Project	<b>IEEE 802.16 Broadband Wireless Access Working Group</b> < <a href="http://ieee802.org/16">http://ieee802.org/16</a> >	
Title	<b>Changes on 802.16e Working Document for IP Address Allocation by Mobile IP</b>	
Date Submitted	<b>2003-09-04</b>	
Source(s)	Jee Hyeon Na, Chulsik Yoon, Jung Mo Moon, Young Jin Kim, Jee Hwan Ahn ETRI 161 Gajeong-Dong, Yuseong-Gu, Daejeon, Korea.	Voice: +82-42-860-5408 Fax: +82-42-860-5471 <a href="mailto:jhna@etri.re.kr">mailto: jhna@etri.re.kr</a>
Re:	This is a response to a Call for Comments IEEE 802.16e-03/18 on IEEE 802.16e-03/07r3	
Abstract	This document contains suggestions on the changes in IEEE 802.16e-03/07r3 that would help IP address allocation in Mobile IP Registration procedure.	
Purpose	The document is submitted for review by Handoff/Sleep mode Ad Hoc Group and/or by 802.16 Working Group members	
Notice	This document has been prepared to assist IEEE 802.16. It is offered as a basis for discussion and is not binding on the contributing individual(s) or organization(s). The material in this document is subject to change in form and content after further study. The contributor(s) reserve(s) the right to add, amend or withdraw material

Table 62-b – Mobile IP Registration

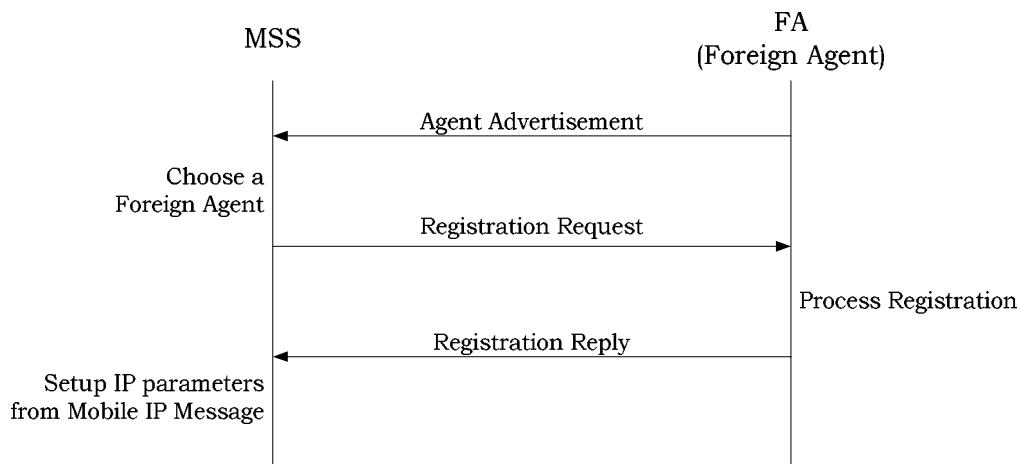
[ Add Under 6.2.9.10.1]

**6.2.9.10.1 Establish IP Connectivity via Mobile IP Registration**

At this point, the Foreign Agent (FA) shall invoke Agent Advertisement message, and then the MSS shall invoke Mobile IP registration [IETF RFC 3344] in order to obtain an IP address and any other parameters needed to establish IP connectivity. The Mobile IP registration response message shall contain the MSS’s IP address and a home agent address of the MSS and other configuration information. Establishment of IP connectivity shall be performed on the MSS’s Secondary Management Connection ; see Table 62-b
